2. Alteration in position of wreck-marking buoy:—

No. 269 (first publication).—The following particulars, etc., relative to the above, issued by the British Admiralty (No. 1180 of 1920), are republished:—

WIRELESS METEOROLOGICAL INFORMATION TO AND FROM SHIPS AT SEA.

Reproduction of Portion of Chart N°1029

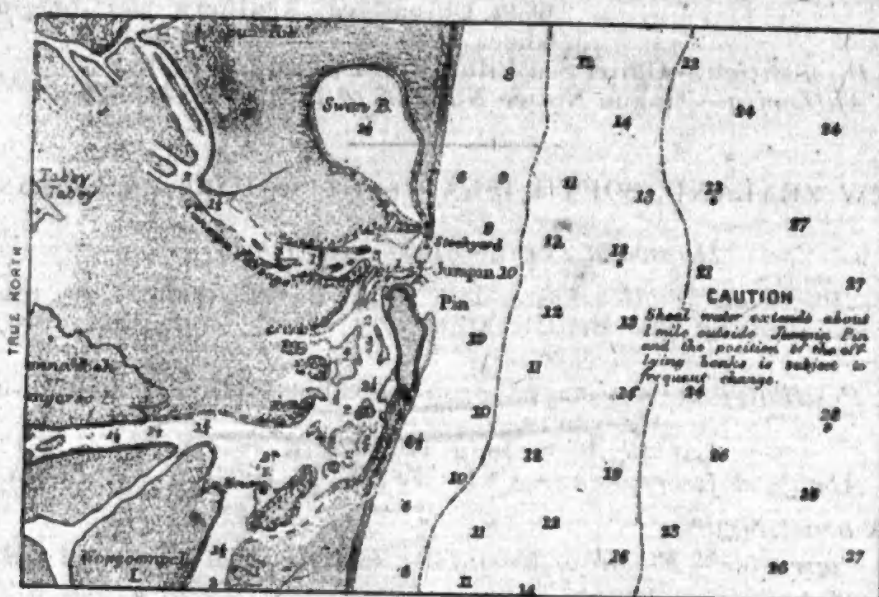
Details.—Amendments to the charts in the locality known as Jumpin pin, southward of Swan Bay, are shown on the accompanying reproduction of portions of charts Nos. 1029 and 3623.

Remarks.—From the reproduction it will be observed that a breach in the coast line, not hitherto shown on the chart, exists in this vicinity. Shoal water due to this opening extends as shown in the cautionary note on the reproduction.

Reproduction of Portions of Chart No. 83.

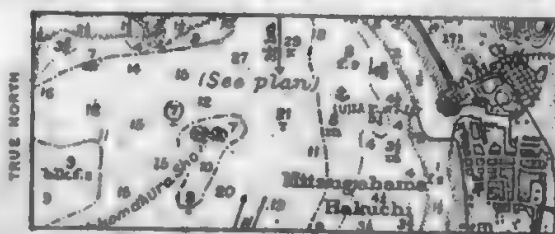
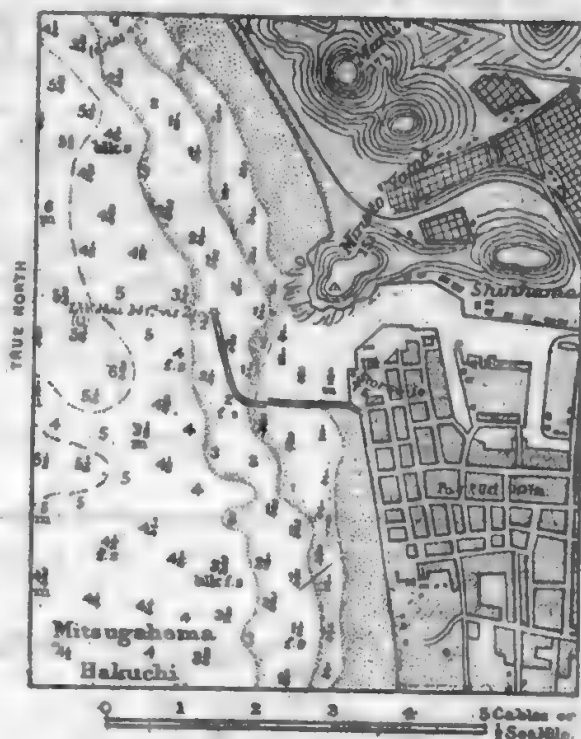
Details.—The accompanying reproductions of portions of charts Nos. 83 and 694 show the necessary amendments with regard to the new harbour works at Mitsugahama.

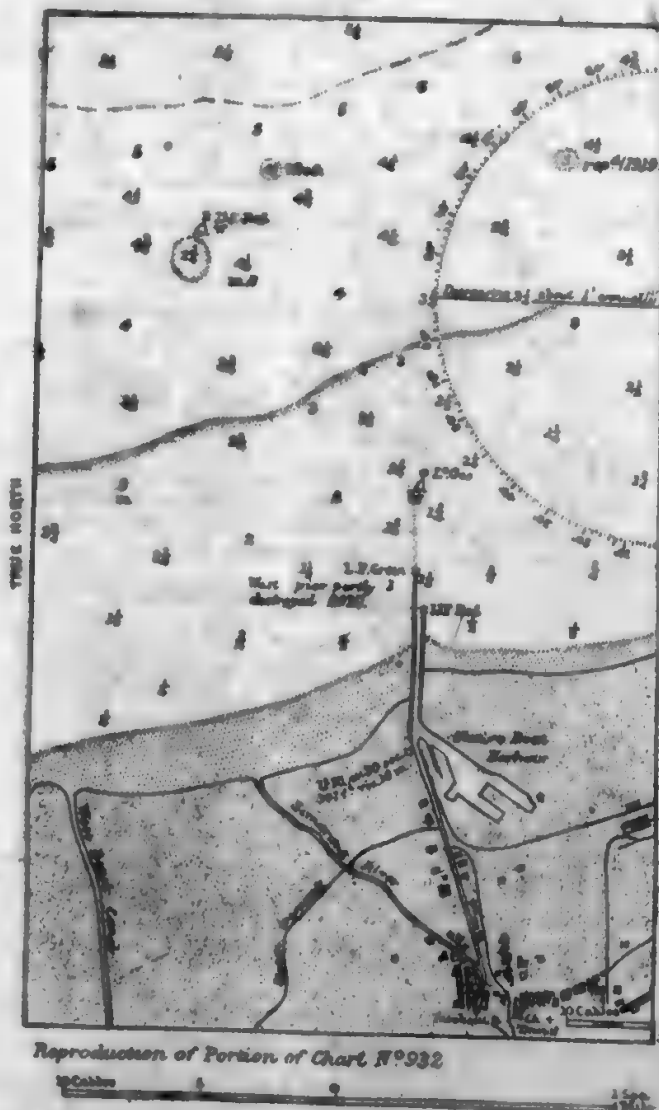
Details.—The accompanying reproduction of a portion of the plan of Semarang bay on chart No. 932 shows the amended position of the 24-fathom shoal, which is now marked by the light-buoy indicated.

The light-buoys and buoys formerly in existence, but which are not shown on the reproduction, have been withdrawn.

Dredging in the approach is no longer in progress and the limits of this area and prohibited anchorage have therefore been omitted from the reproduction.

Reproduction of Portion of Chart No. 2201

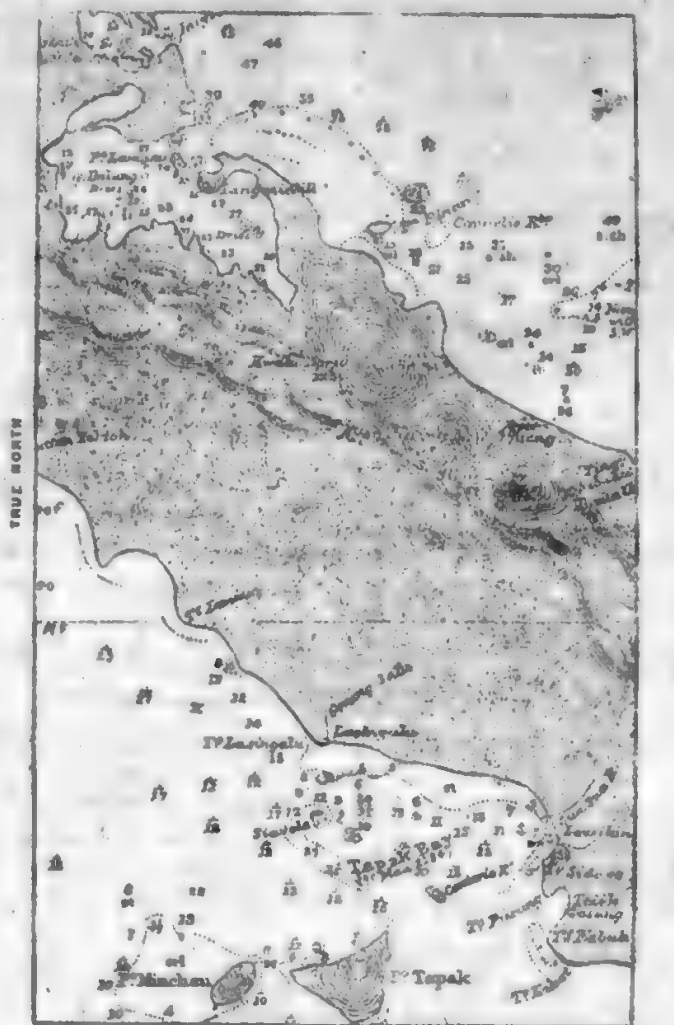
Details.—The accompanying reproduction of a portion of chart No. 2201 shows amendments to the chart with regard to shoals off the entrance to Telok Dalam and northward of Pulo Minchau.

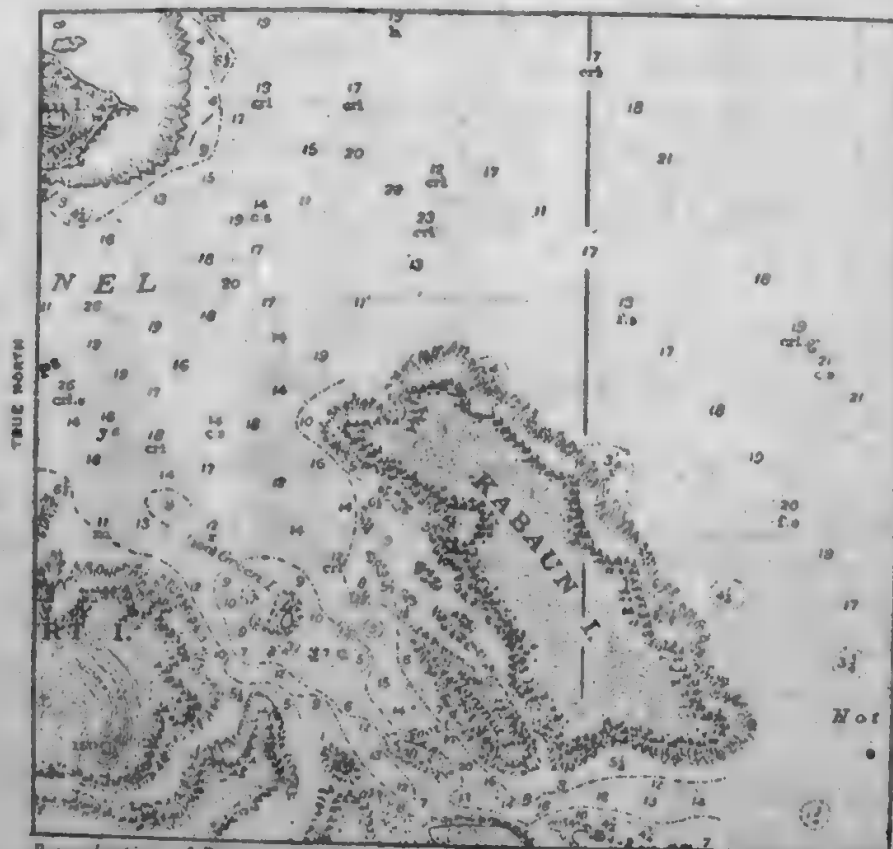
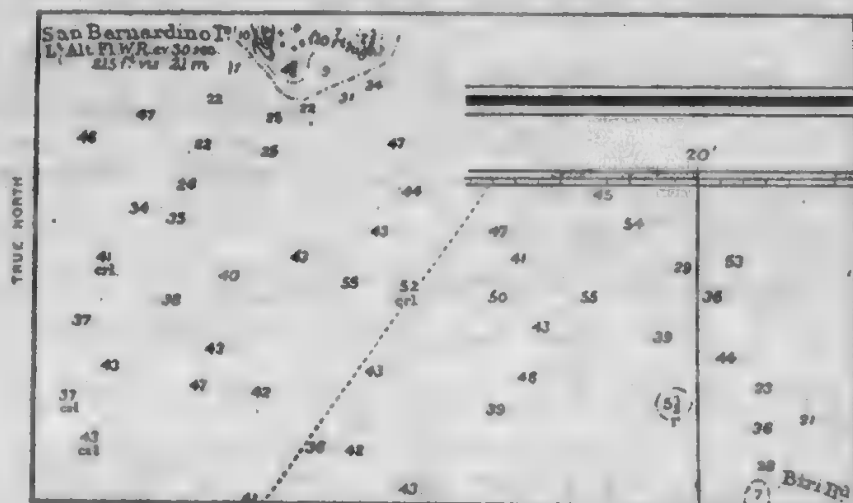
Details.—The accompanying reproduction of portions of chart No. 3370 show the necessary amendments with regard to shoals in the vicinity of San Bernardino islets and Kabuan island.

Reproduction of Portion of Chart N°1029

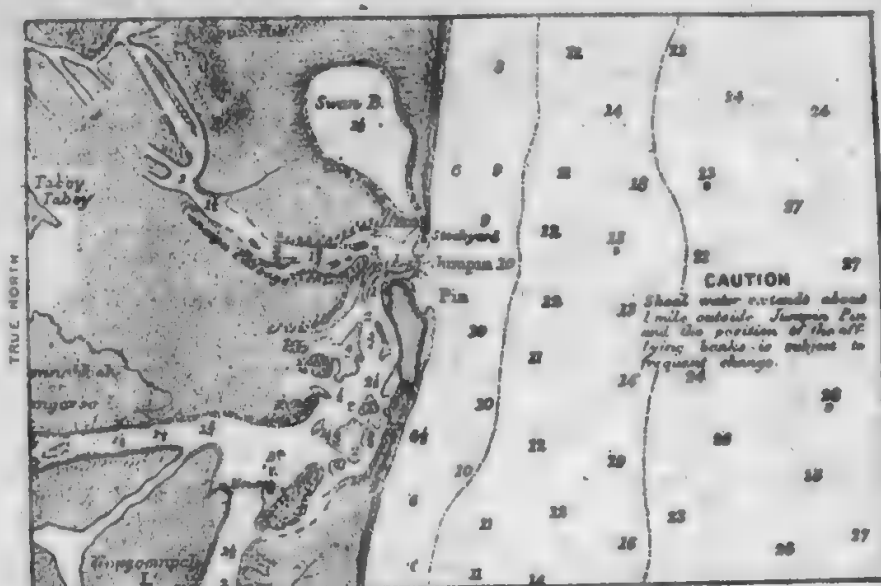
Details.—Amendments to the charts in the locality known as Jumpin pin, southward of Swan Bay, are shown on the accompanying reproduction of portions of charts Nos. 1029 and 3623.

Remarks.—From the reproduction it will be observed that a breach in the coast line, not hitherto shown on the chart, exists in this vicinity. Shoal water due to this opening extends as shown in the cautionary note on the reproduction.

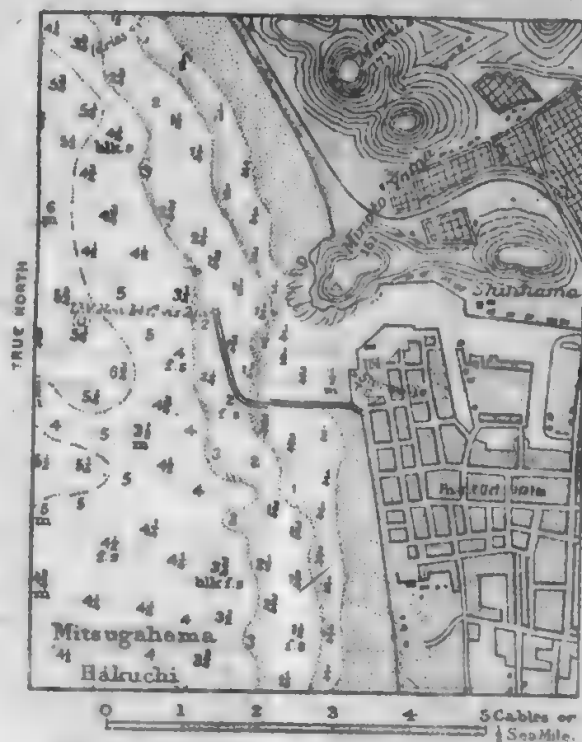
Details.—The accompanying reproductions of portions of charts Nos. 83 and 694 show the necessary amendments with regard to the new harbour works at Mitsugahama.

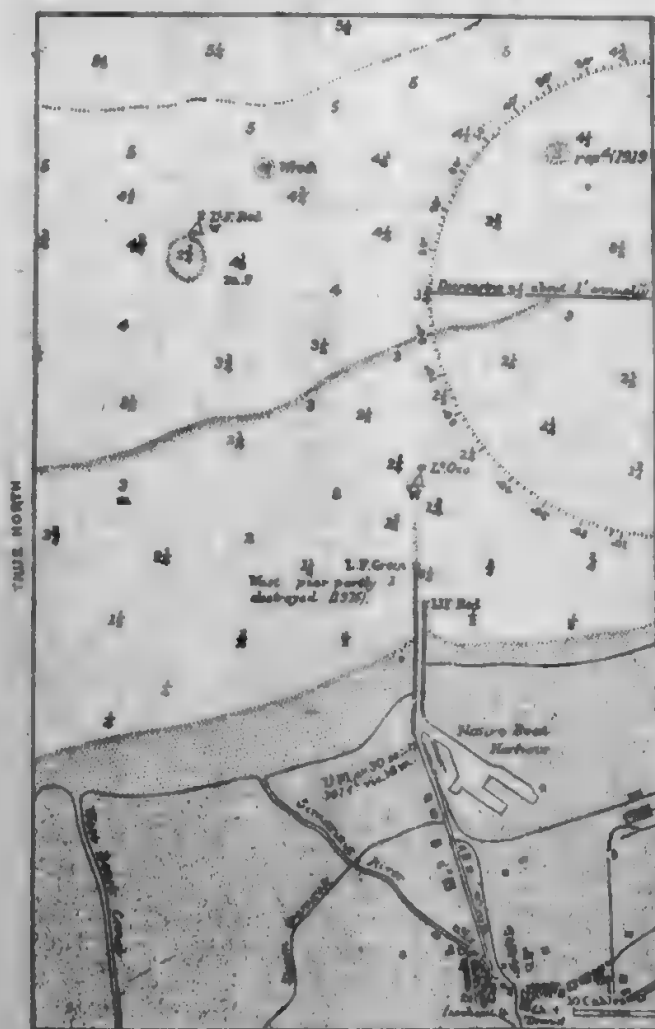
Details.—The accompanying reproduction of a portion of the plan of Semarang bay on chart No. 932 shows the amended position of the 27-fathom shoal, which is now marked by the light-buoy indicated.

The light-buoys and buoys formerly in existence, but which are not shown on the reproduction, have been withdrawn.

Dredging in the approach is no longer in progress and the limits of this area and prohibited anchorage have therefore been omitted from the reproduction.

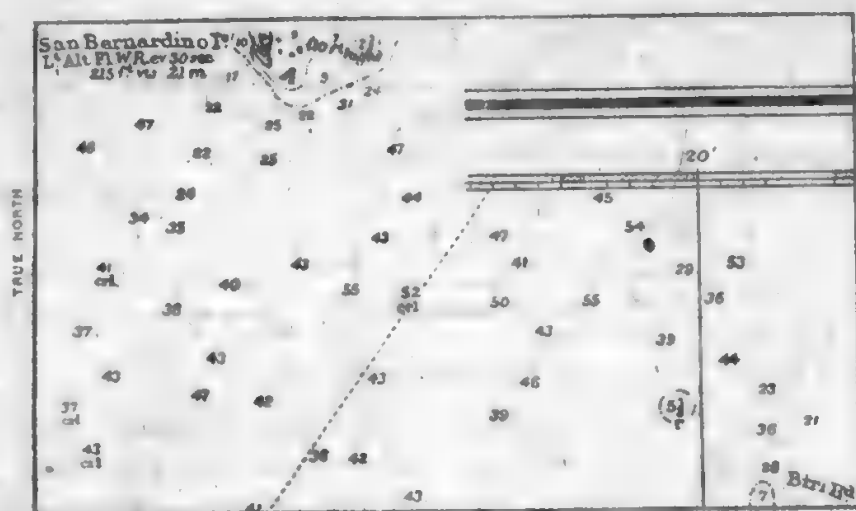
Details.—The accompanying reproduction of portions of chart No. 3370 show the necessary amendments with regard to shoals in the vicinity of San Bernardino islets and Kabuan island.

Reproduction of Portion of Chart No. 1235.

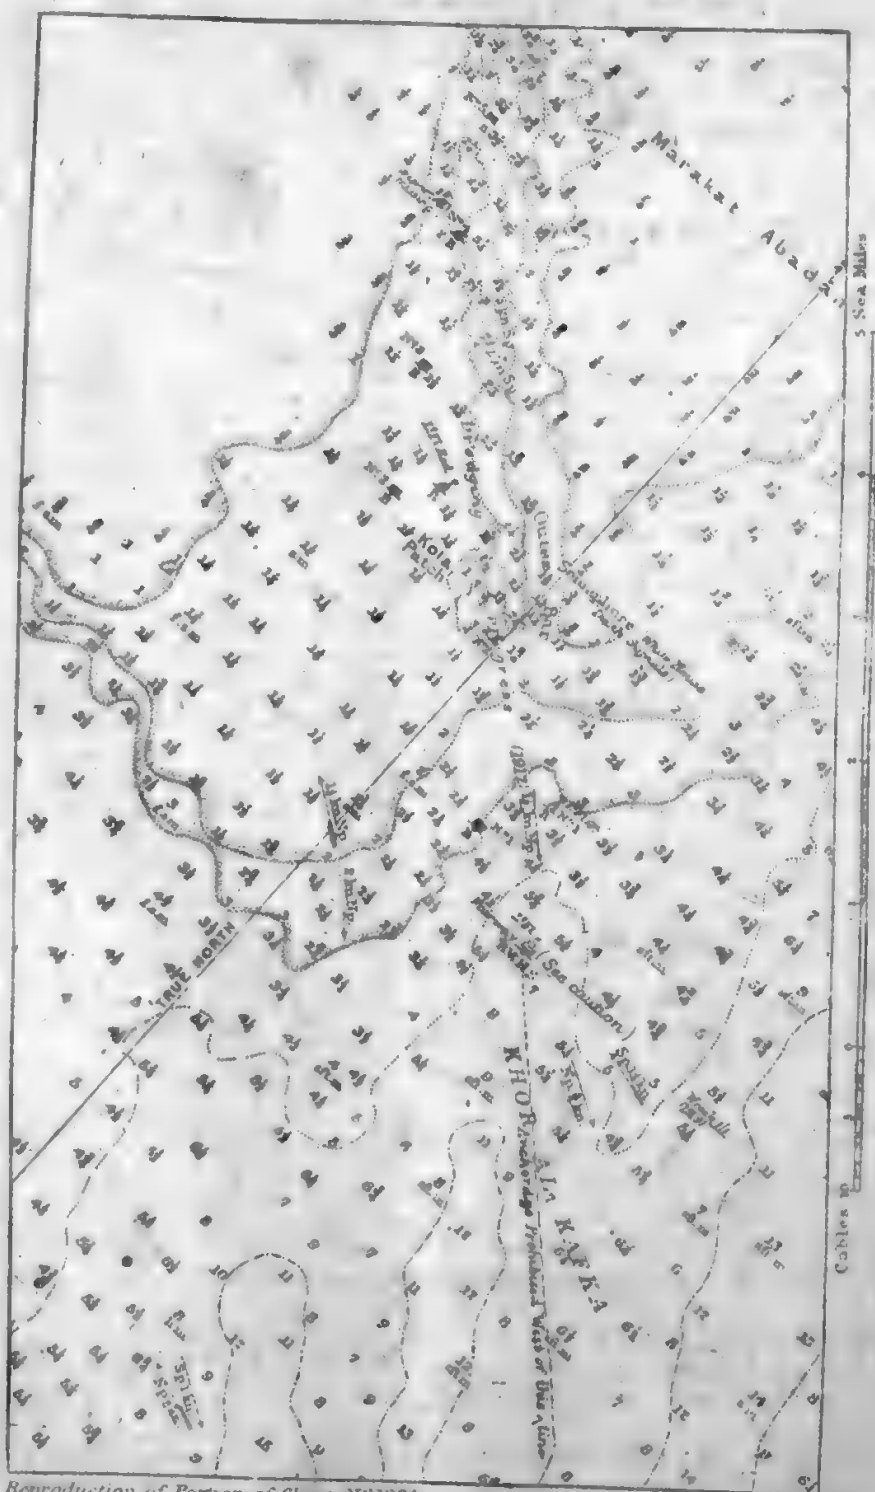
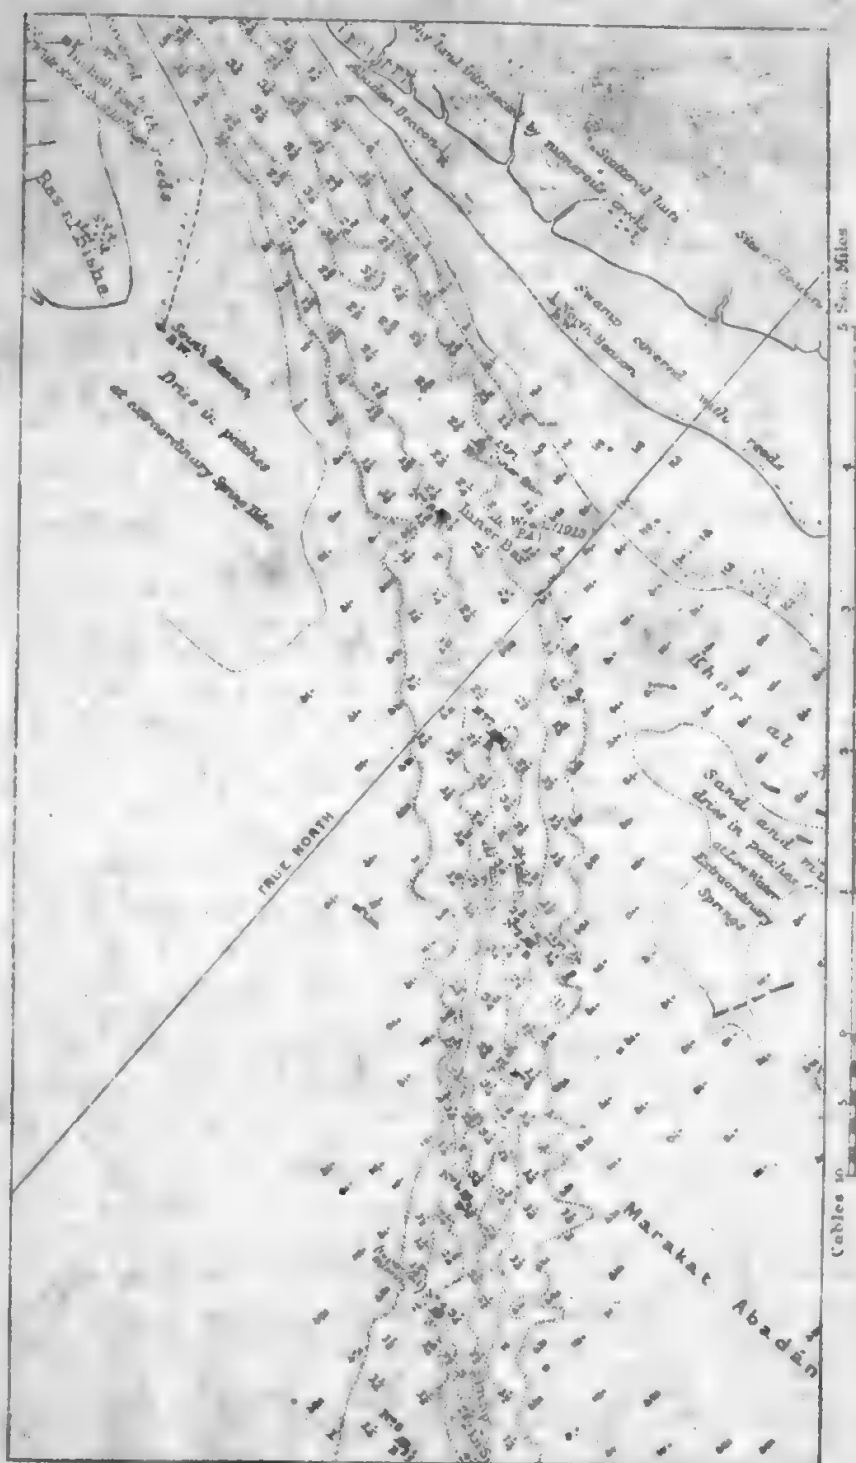
Chart affected.—No. 1235, Mouth of the Euphrates.
